PRODUCT CHANGE NOTIFICATION (PCN)

AMJE0909-0700-GNB-24
MODULAR CABLE

CHANGE NOTIFICATION: PCN 20220509_AMJE0909-0700-GNB-24

DESCRIPTION OF CHANGES:
CHANGE OF DATA SHEET
CHANGE OF DATA SHEET
New Draw.-No. ASS_7945_CArev02

AMJE0909-0700-GNB-24 OLD VERSION

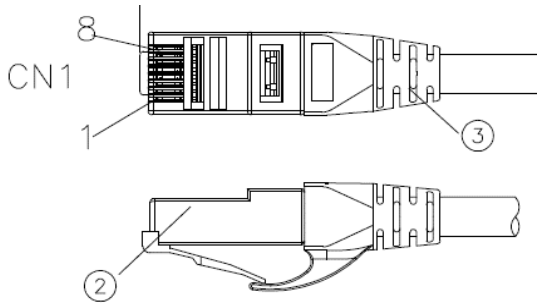
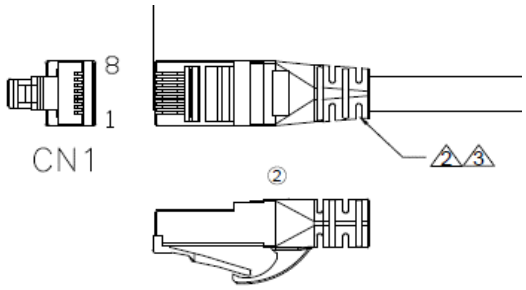
③	Molding	PVC 45P Color: see order code	NA	KG
②	CONNECTOR	RJ45 8P8C two fork Short type 3u" gold plated	2	PCS
①	CABLE	CAT6 UTP (24AWG*1PR)*4+PVC OD=5.8±0.3MM Color: see order code	NA	MM
NO:	NAME	DESCRIPTION	Q'TY	UNIT

3	Molding	PVC 65P Color: see order code ②	NA	KG
2	CONNECTOR	RJ45 8P8C PLUG 3u" gold plated ②	2	PCS
1	CABLE	CAT6 U/UTP (24AWG*1PR)*4+Cross+PVC Jacket OD=5.8± 0.3MM Color: see order code ②	NA	MM
NO:	NAME	DESCRIPTION	Q'TY	UNIT

Drawing-No.
ASS 7945 CA

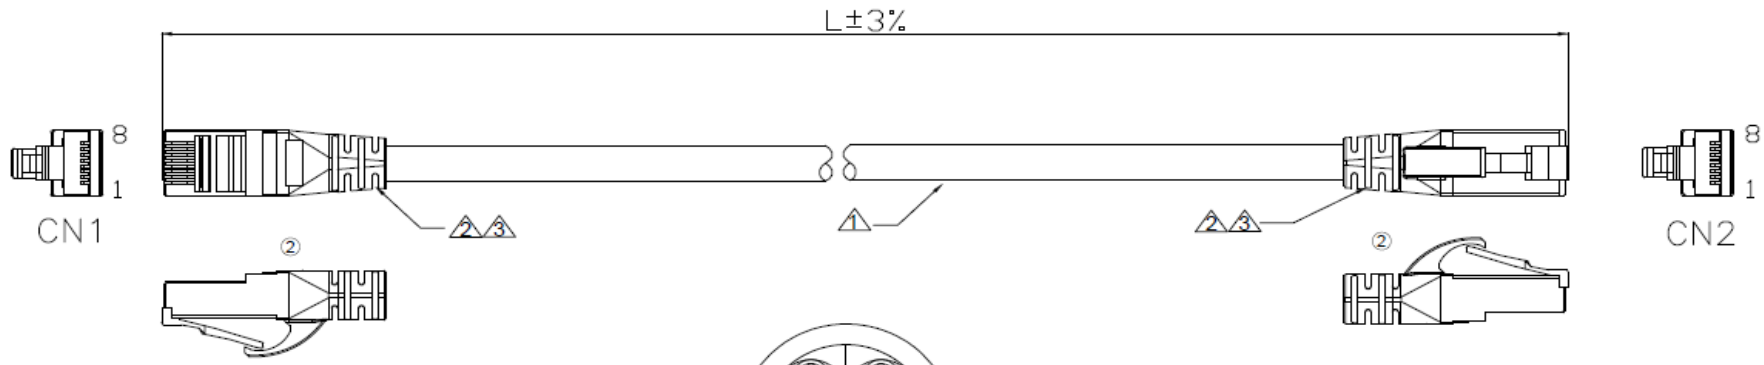
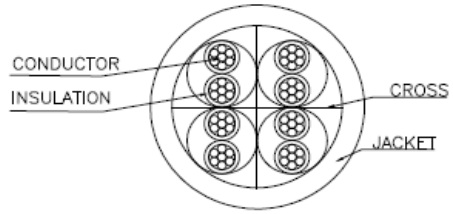
Id.	Modification	Date	Name
②	Change the plant	09.05.2022	Luca
①	Update the WSW order code	02.06.2017	Amy
⓪	Drawn	30.03.2017	Amy

NO:	NAME	DESCRIPTION	Q'TY	UNIT
3	Molding	PVC 65P Color: see order code ②	NA	KG
2	CONNECTOR	RJ45 8P8C PLUG 3u" gold plated ②	2	PCS
1	CABLE	CAT6 U/UTP (24AWG*1PR)*4+Cross+PVC Jacket OD=5.8± 0.3MM Color: see order code ②	NA	MM
